### ADDENDUM NO. 1

Project Name: **Okeechobee County Project No. 2017-03  
Additions for The Landing Strip Café**

Date: **March 24, 2017**

SK = 4

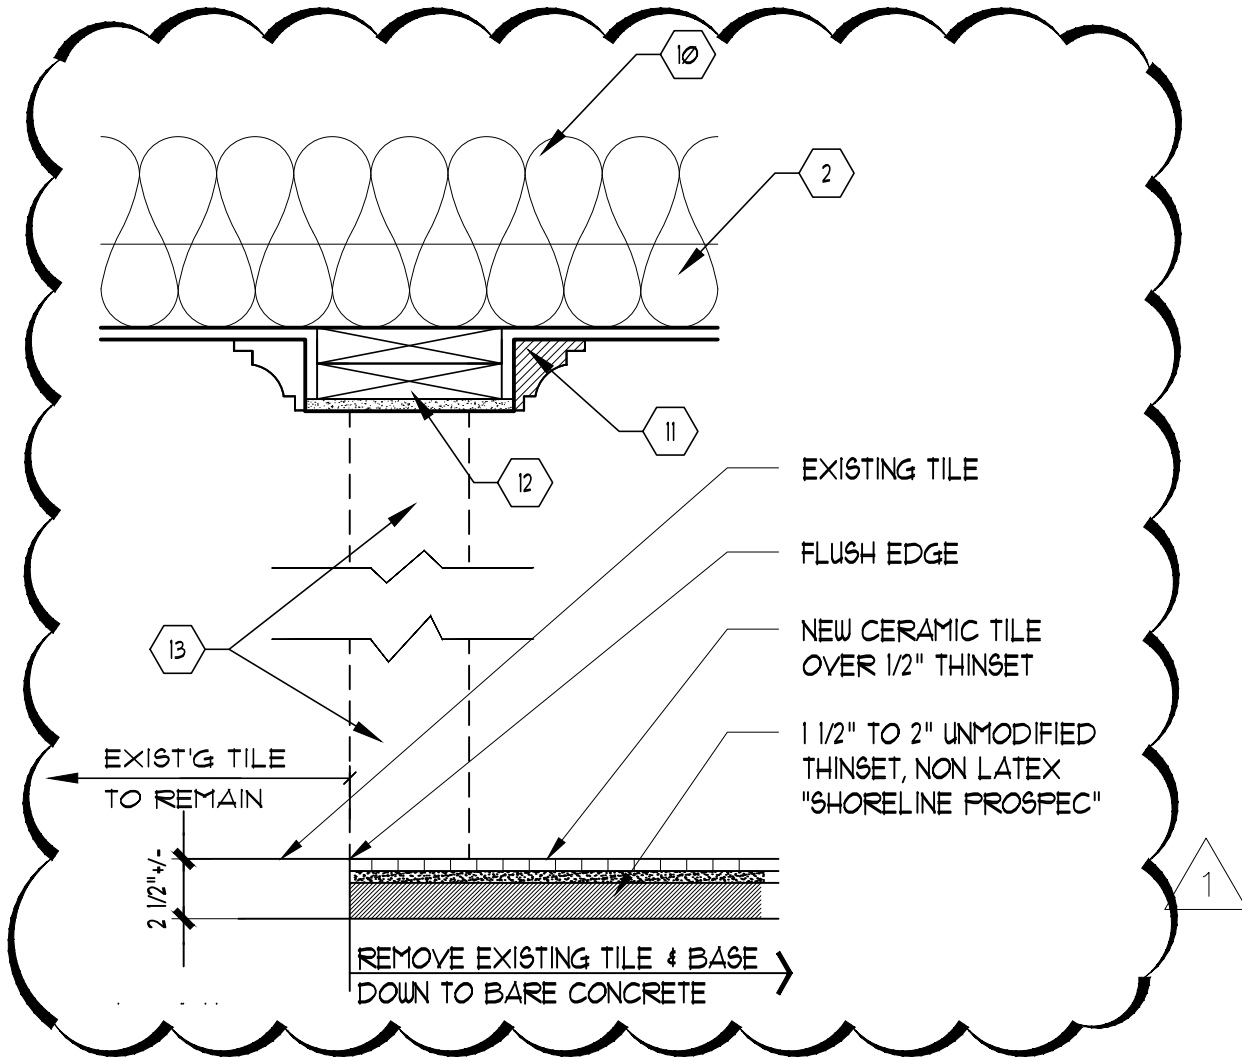
3. Will a new ceramic floor be installed in the outside Dining area that is to be enclosed?  
**A NEW CERAMIC TILE FLOOR WILL BE INSTALLED IN THE NEW ENCLOSED DINING AREA. THE CONTRACTOR WILL REMOVE THE EXISTING MORTAR BED AND MATERIAL DOWN TO CONCRETE BASE. (SEE ATTACHED PARTIAL DETAIL SK-4)**
